## Addendum No. 1

Project Name: SCC – P. Dan Hull Building Roof Replacement  
Project Number: H59-6273 - PD

WMBE Project Number: 2023-47

**R-1.1**

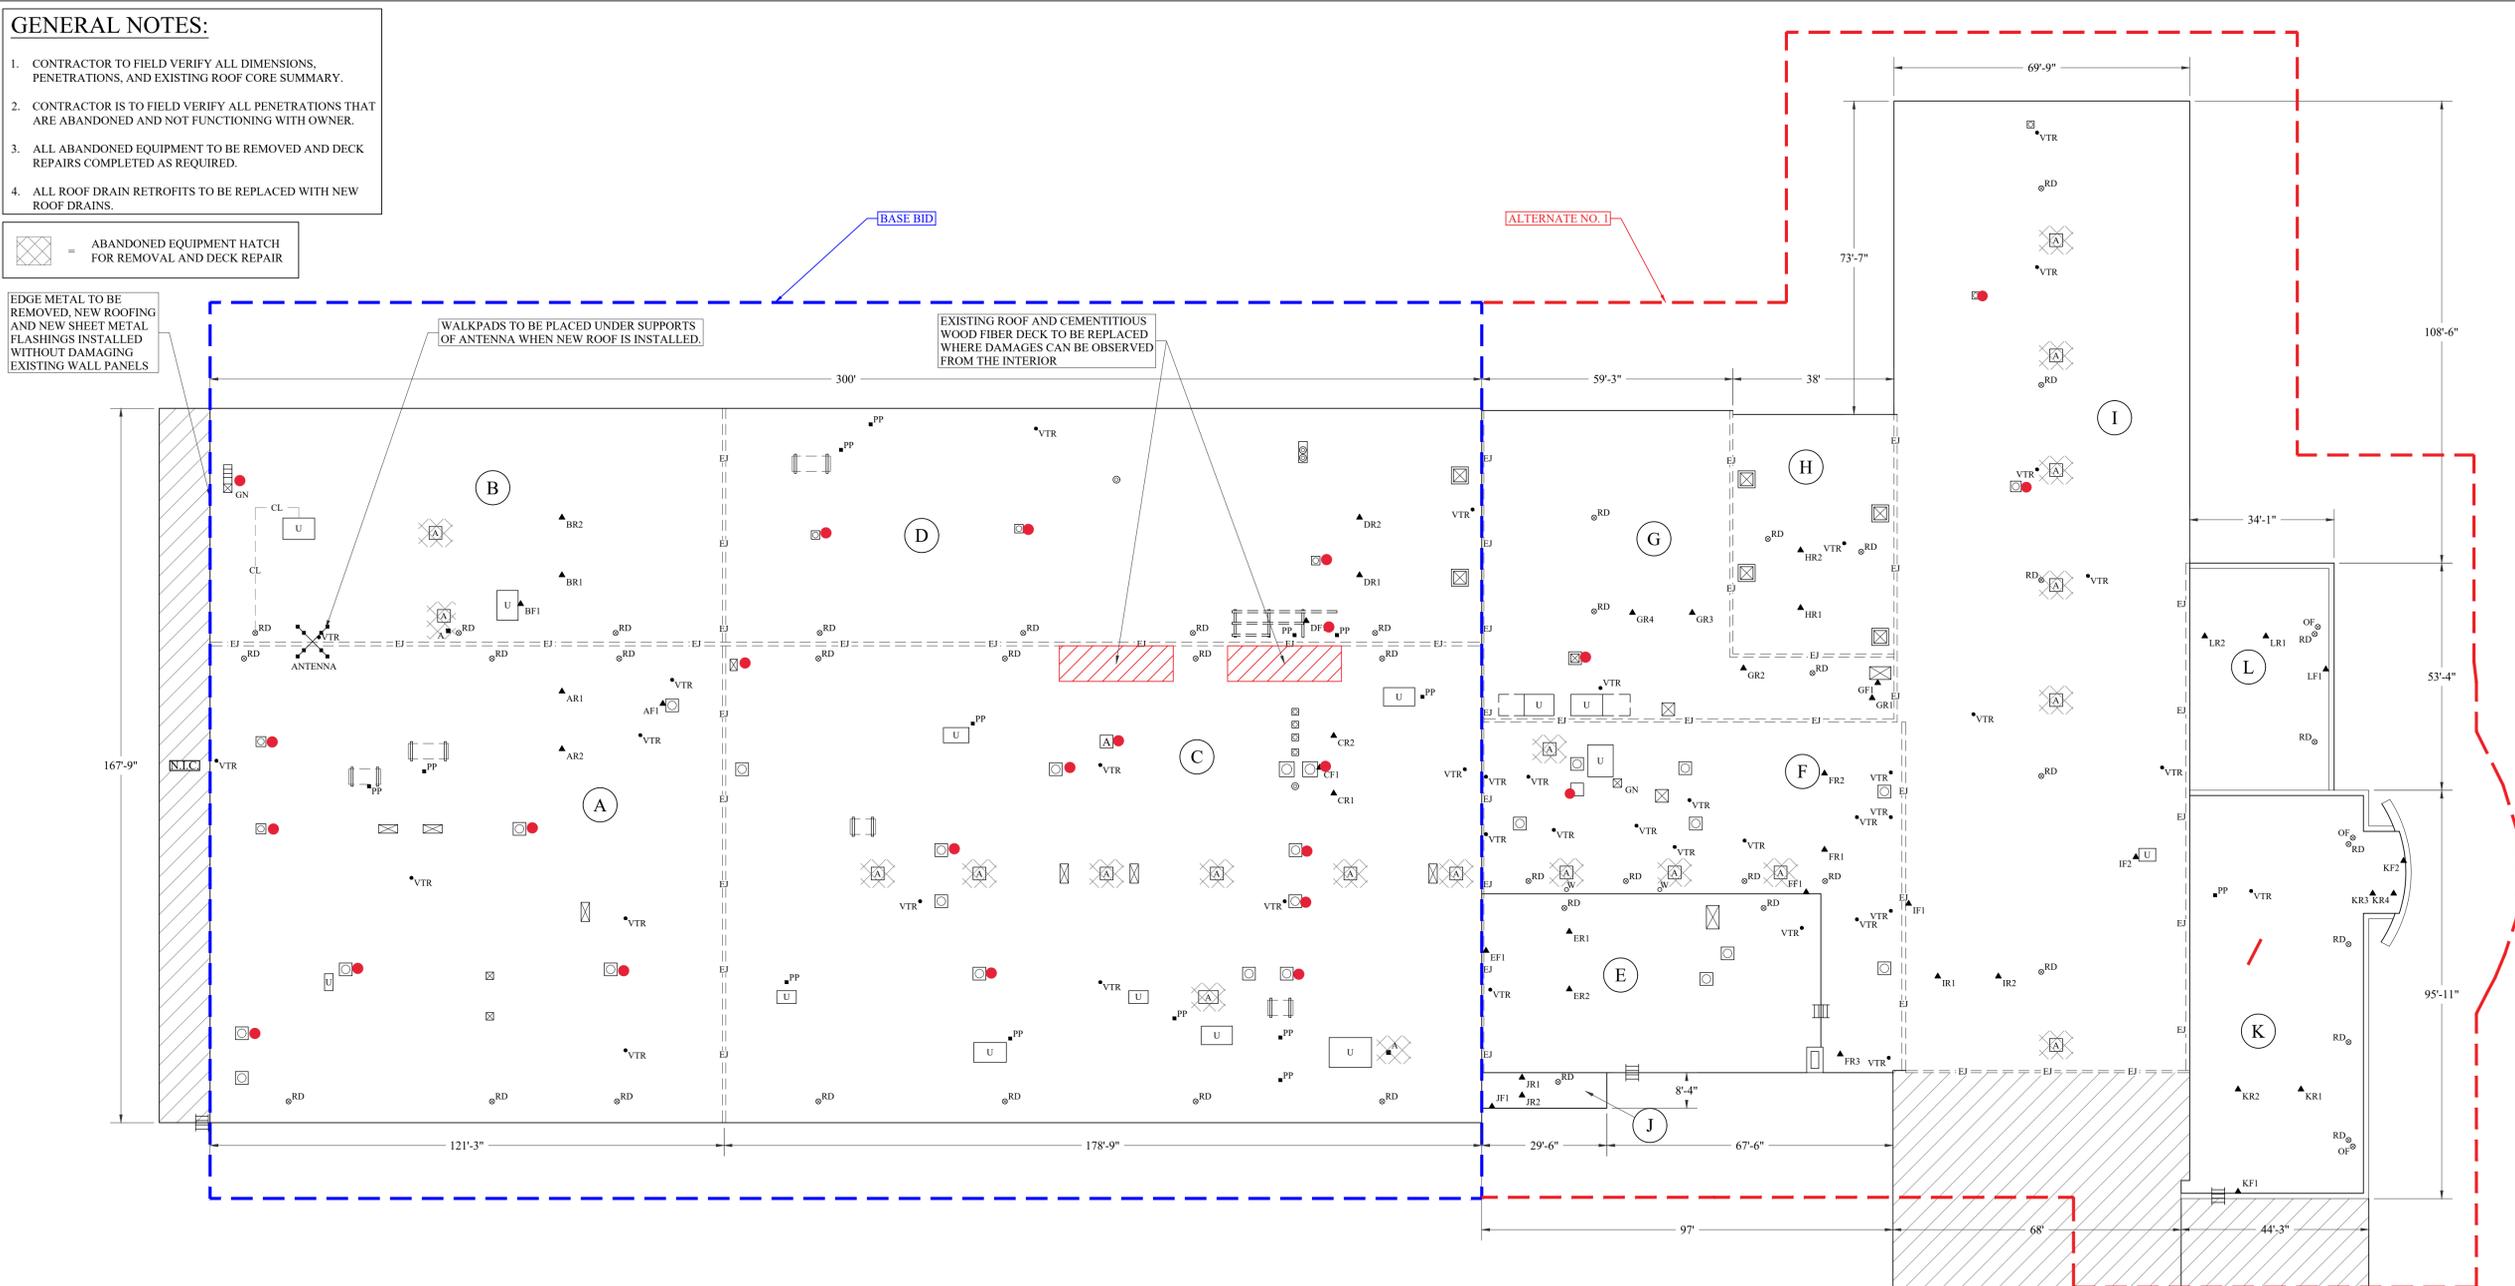
1. Changes to Bidding Requirements:
  - a. None.
2. Changes to Specifications:
  - a. None
3. Changes to Drawings:
  - a. Additional Drawing sheet provided in addendum for additional mechanical units and associated penetrations to be removed.

3. Question: How many units are abandoned to be removed?

Answer: In addition to the areas hatched with the cross hatch to be removed on the drawing plans there are approximately a total of (24) pieces / ventilators that are additional items to be removed.

(21) exhaust fans to remove. (2) HVAC units. One is a green colored "Swamp Cooler" we call it over the Kitchen. The other is the very old, abandoned HVAC unit sitting on the rusted steel above E46 HVAC lab. (1) Roof cap covered with sheet metal above E46 HVAC lab sink.

Plan is attached for reference marked with a red dot.

ABANDONED EQUIPMENT HATCH FOR REMOVAL AND DECK REPAIR

1 EXISTING ROOF PLAN

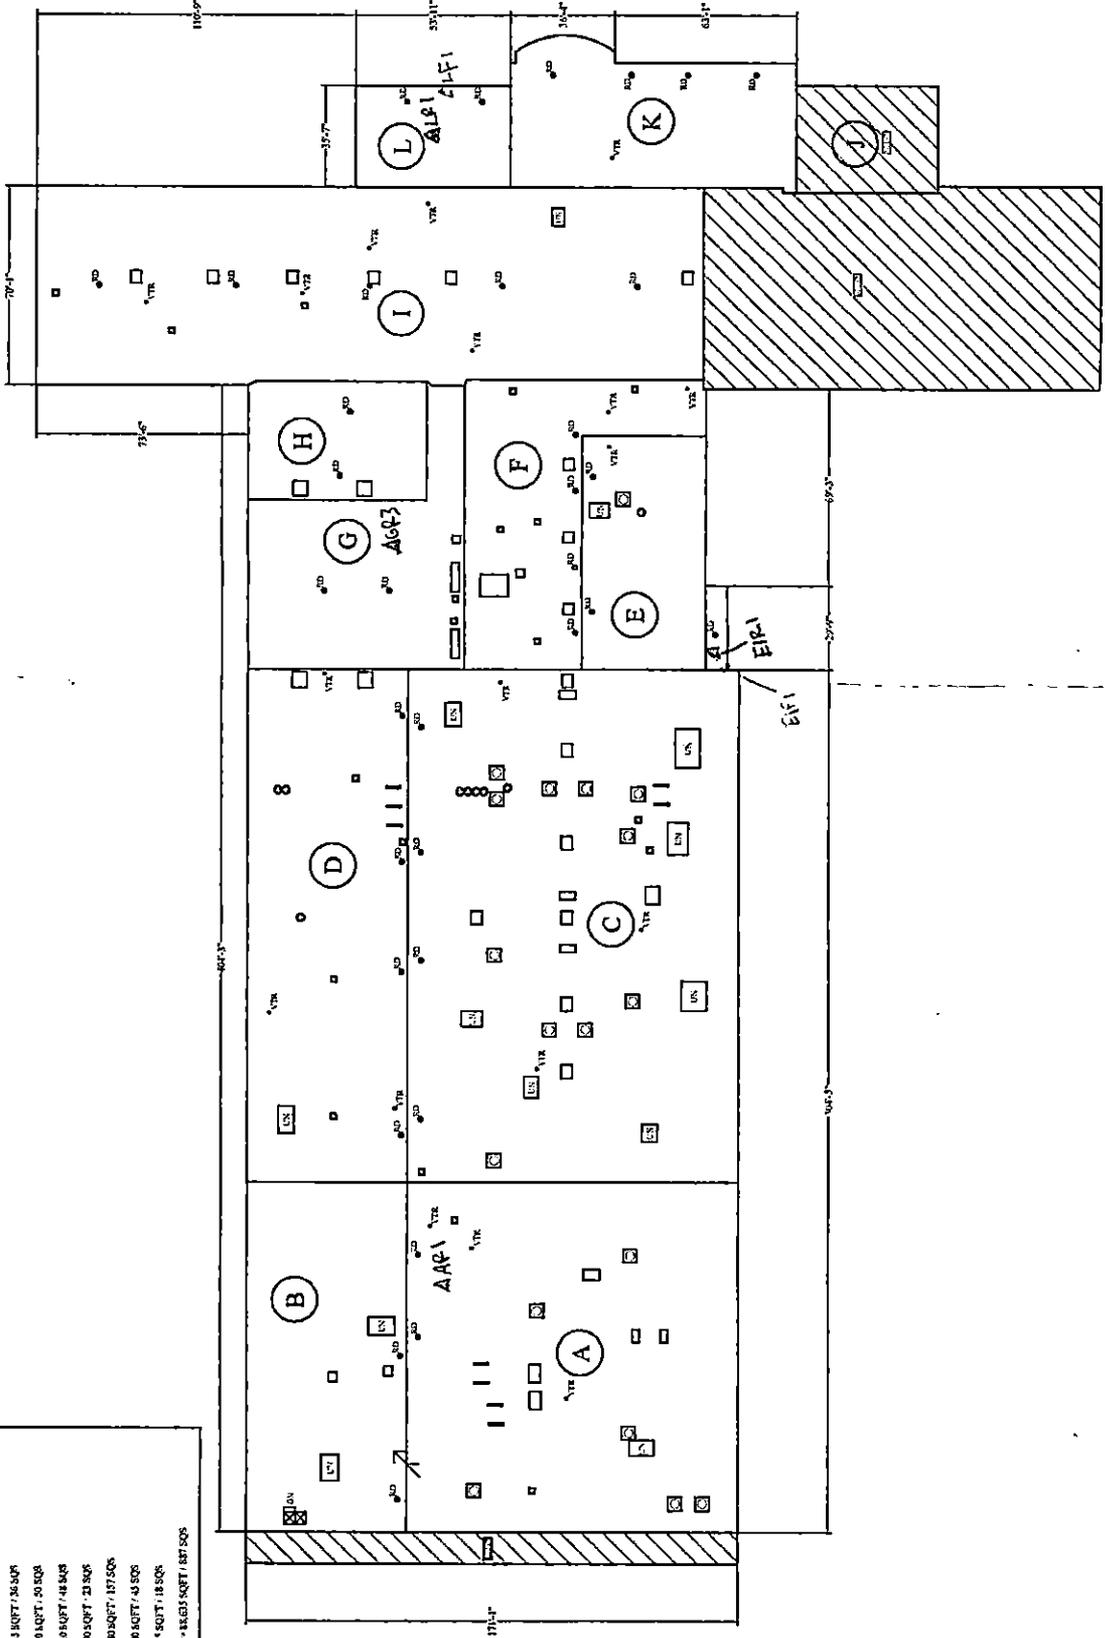
4. Question: Are there specific locations expected to have existing wet insulation to be removed and replaced.

Answer: Plan is attached with areas in red where test cuts will be completed prior to removal using the unit price line item.

RED AREAS ARE ANTICIPATED AREAS OF EXISTING WET ROOF INSULATION THAT WILL BE REMOVED AND REPLACED WITH NEW USING THE UNIT PRICE. TEST CUTS SHALL BE COMPLETED TO CONFIRM.
